5 July 2018
Ref: J2266L_3.docx

**PROPOSED RESIDENTIAL CARE FACILITY (RCF) – OPAL AGED CARE
TOONGABBIE SPORTS AND RECREATION CLUB & ADJACENT LOTS
CITY OF PARRAMATTA COUNCIL DA/1281/2016
INDEPENDENT REVIEW OF FLOOD RISKS**

Figure 1: The Site superimposed on Council's Flood Map
(Source: Attachment A of Martens & Assoc letter dated 31 May 2018)

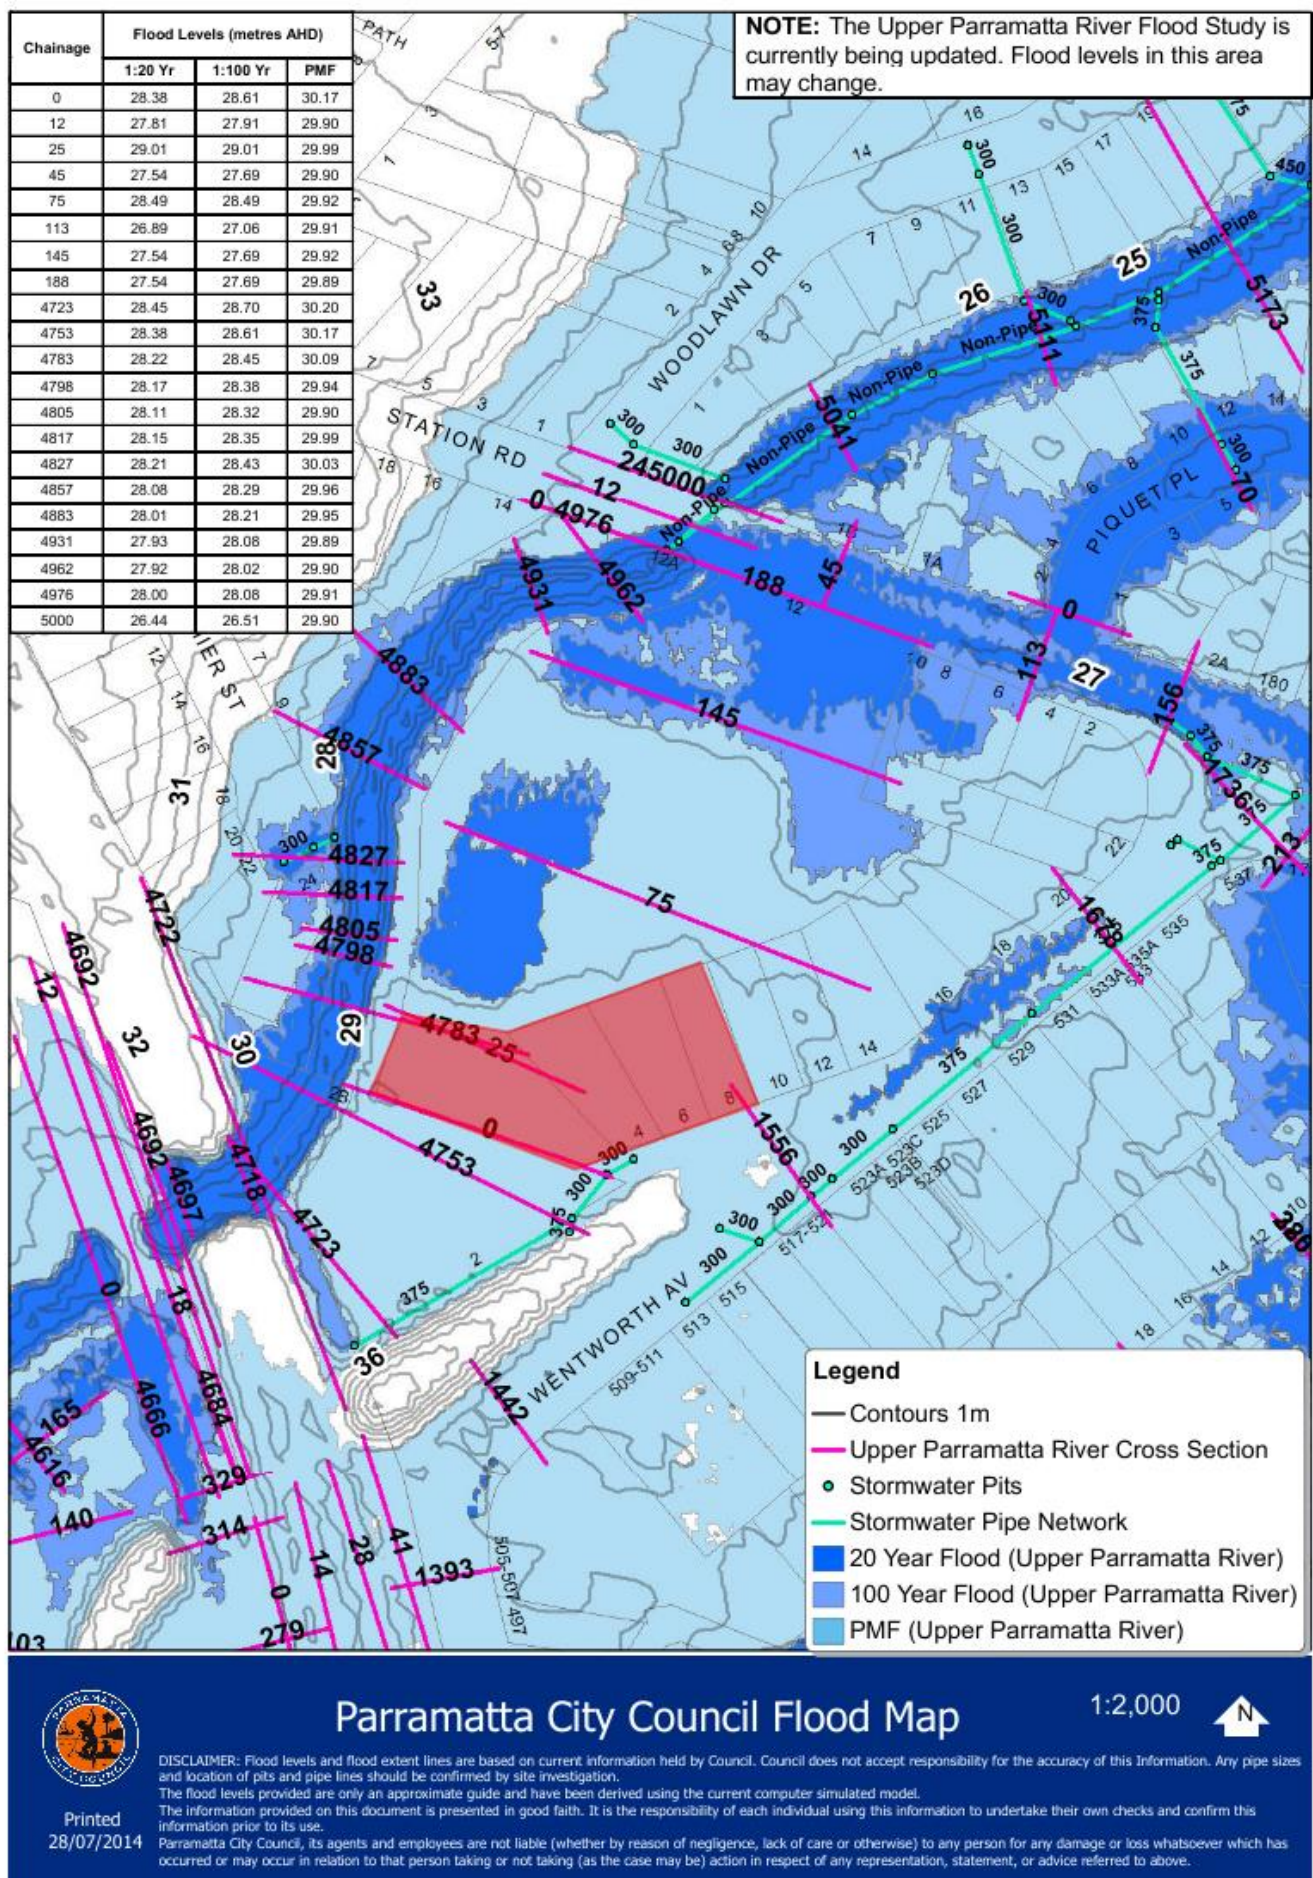
- (b) “... the proposed building siting in the floodway ...”.⁶ (The Site is not in a floodway);
 - (c) “Although the building footprint is technically above the 1% flood level, much of this site is below”.⁷ (None of the Site is below the 100 year flood level – refer **Figure 1**);

- (d) “... much of the site is flood affected during the 1% AEP event ...”.⁸ (None of the Site is inundated in a 1% AEP flood event – refer **Figure 1**).

Figure 2: The Site superimposed on Council's Flood Hazard Map
(Source: Attachment A of Martens & Assoc letter dated 31 May 2018)

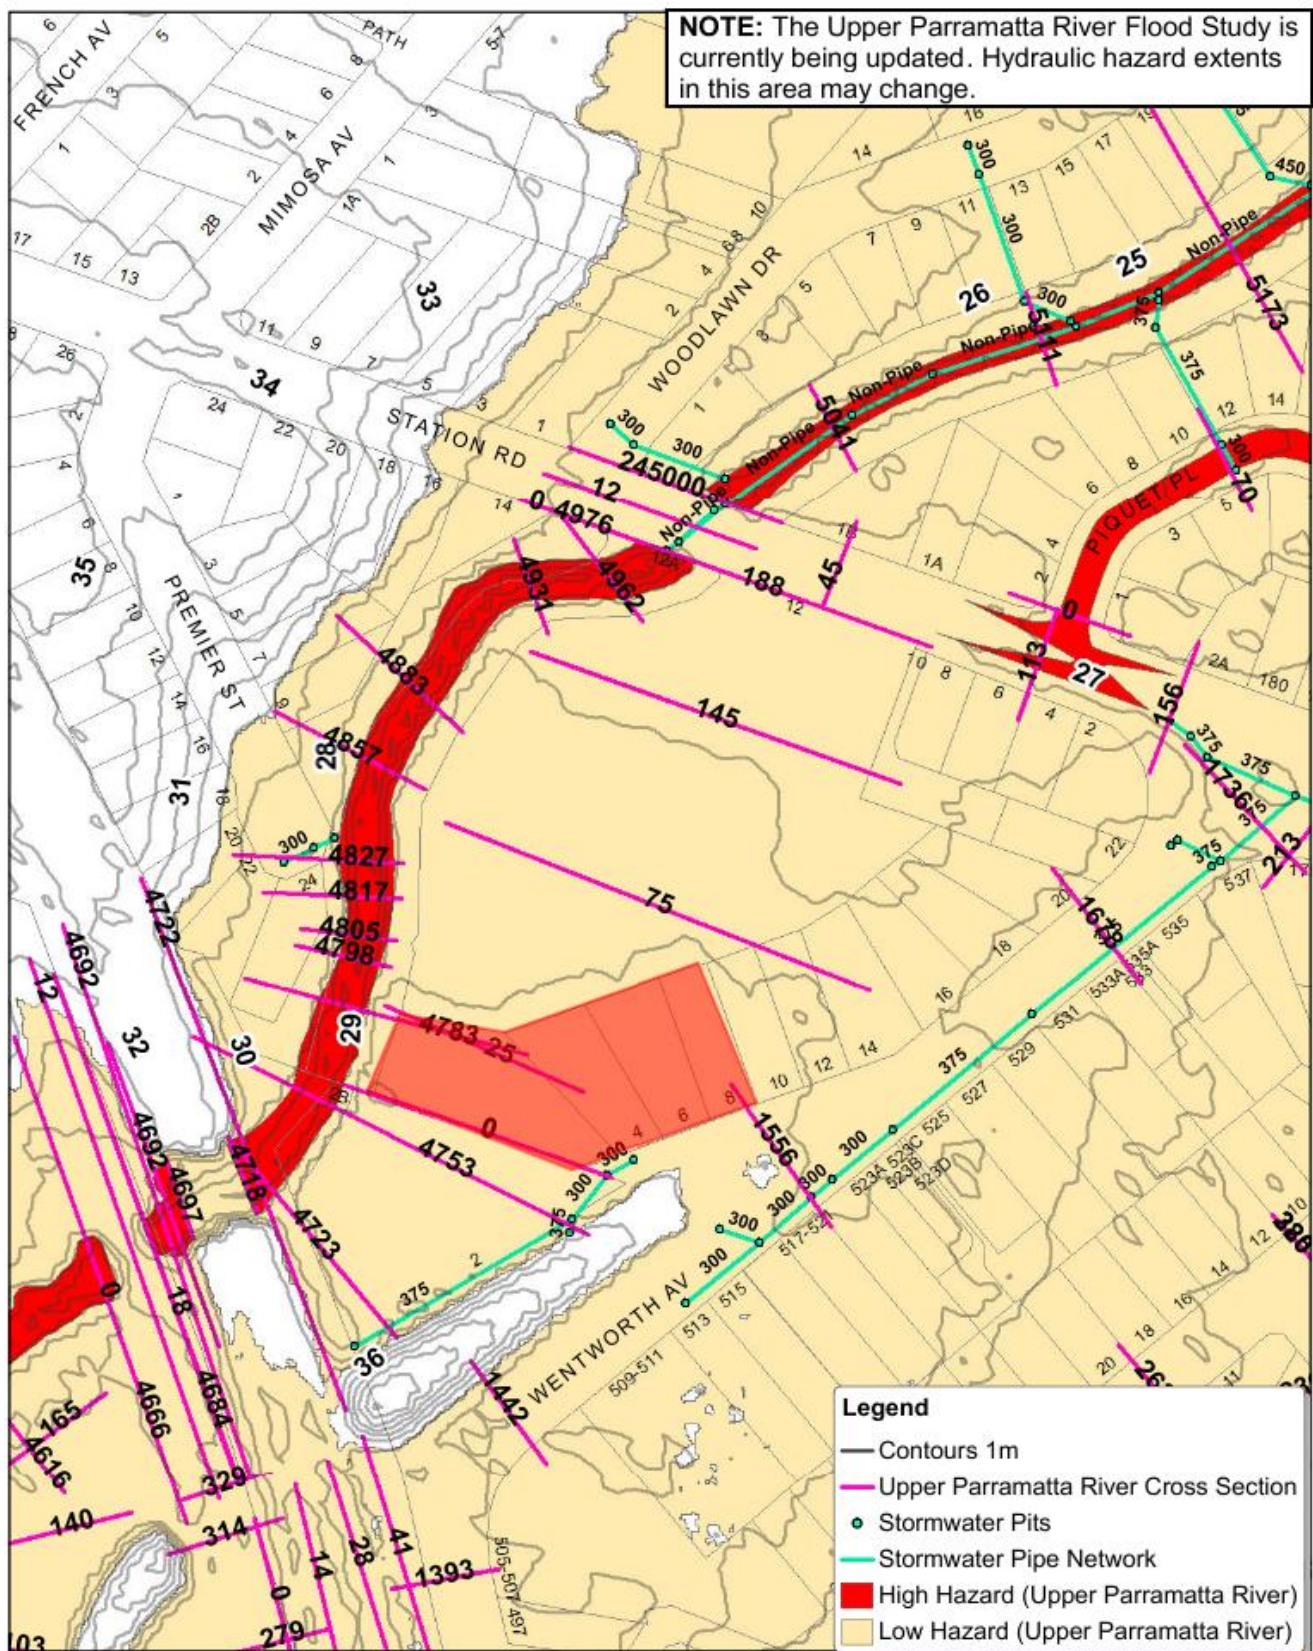
- (a) “The site and the surrounding area are subject to major low, medium and high hazard flooding”.⁵ (As can be seen from **Figure 2** the entirety of the Site is on low hazard land);
